# REEDISHA TEXSTRIPE LTD. (EXTENSION)

26 January 2025

### Observation-1: Inconsistency and lack of information in the EA report (Building 11, Building 13).

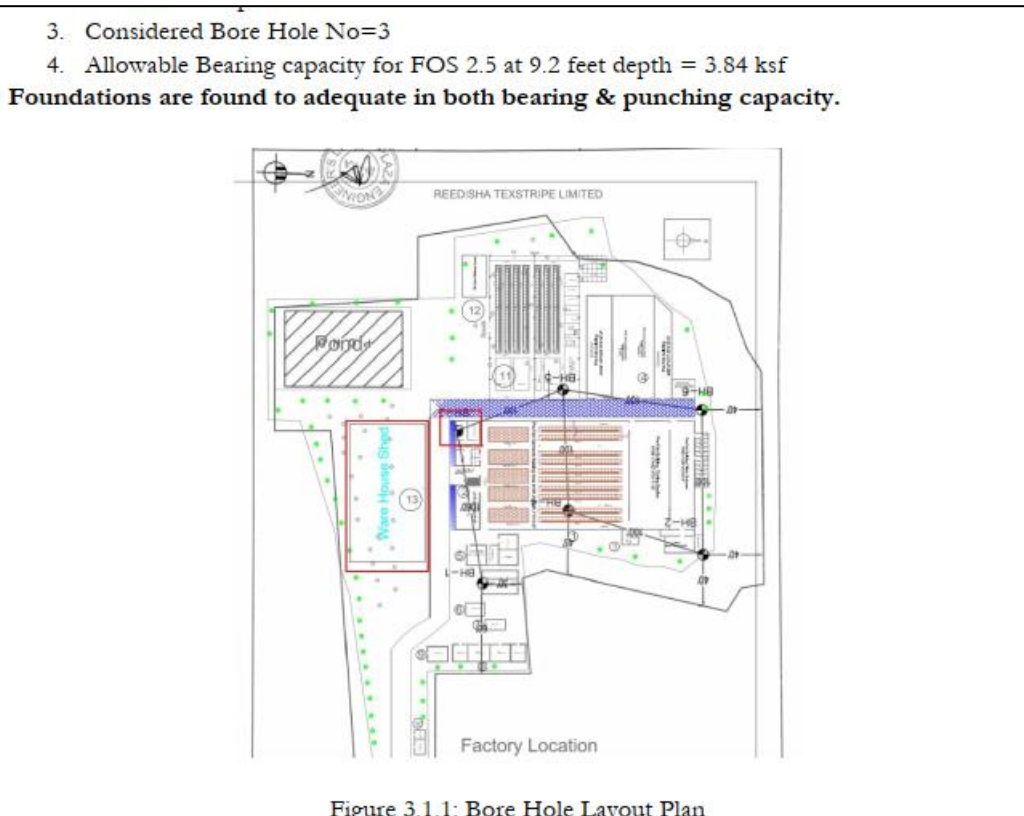
Concrete strength ( $f'_c$ ) was considered 37.8 MPa and 33.67 MPa but core strength evaluation calculation, was not incorporated. Also, all steel member strength was considered 345 MPa but adequate number of plate test reports were not provided.

Seismic response modification coefficient  $R=8$  was considered but no checks were provided to confirm the IMRF system for the RCC portion.

**Description:** The building engineer is required to conduct necessary testing of the steel member (plate & angle) to confirm the 345 MPa design strength for all steel members. Incorporate all IMRF checks as per BNBC Part-VI section 8.3.10 and the core strength evaluation calculation in the EA report.

These checks should be verified and incorporated into the design report to ensure full alignment with the code provisions.

Building 11: lack of compression strut in E-W direction.

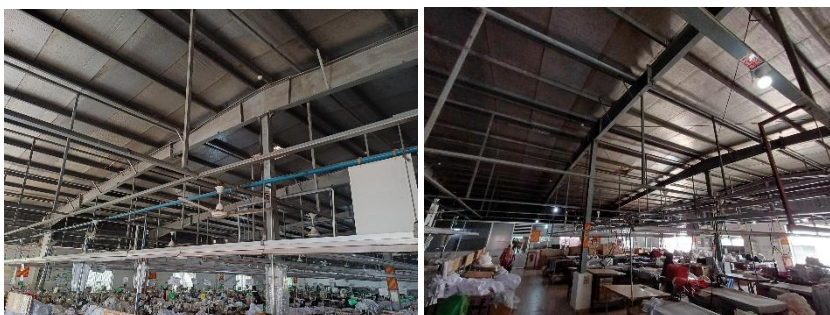
**Observation-3:** Lack of lateral load transfer media (strut) and load resisting system. (Building 11)

**Description:** Lack of bracing system along the long direction of the shed was observed. The building engineer is required to check the lateral stability and suggest adequate size of strut member. Submit the EA report to RSC for review.

SCHEDULE OF COLUMN REINFORCE	
NAME OF COLUMN	UP TO +1000 FROM PLIN
C1	 <p>500 400 ● 12-20 mm Ø Tie Bar: 10mm@150 c/c</p>

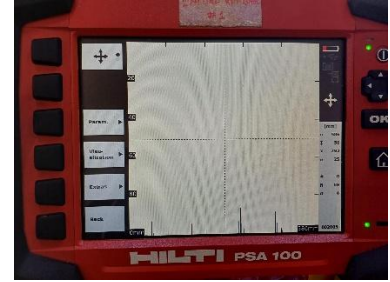
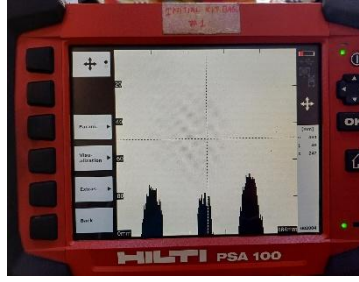
As per drawing, all RC column is C1 with 12 no's re-bar profile

On-site ferro scanning, the RC column C1 re-bar profile found 10 no's instead of 12 no's

**Description:** During inspection, the discrepancy was found between the provided as-built drawing and the actual site condition. The building engineer is required to survey the structure and update the as-built drawing as per the actual site condition.

Building 13: lack of lateral stability in Steel stair & parking

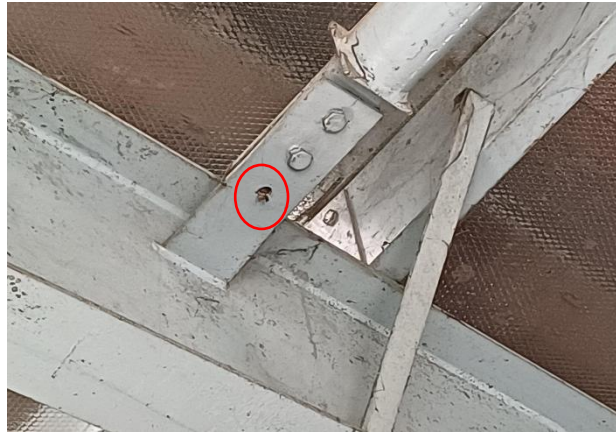
**Observation-8:** Lack of lateral load transfer media (bracing & strut) and load resisting system. (External Steel Stair & Parking (Building 13))

**Description:** Lack of bracing system along the long direction of the shed was observed. The building engineer is required to check the lateral stability and suggest adequate size of bracing and strut member. Prepare a safety check report as per the Accord Building Standard and submit to RSC for review.
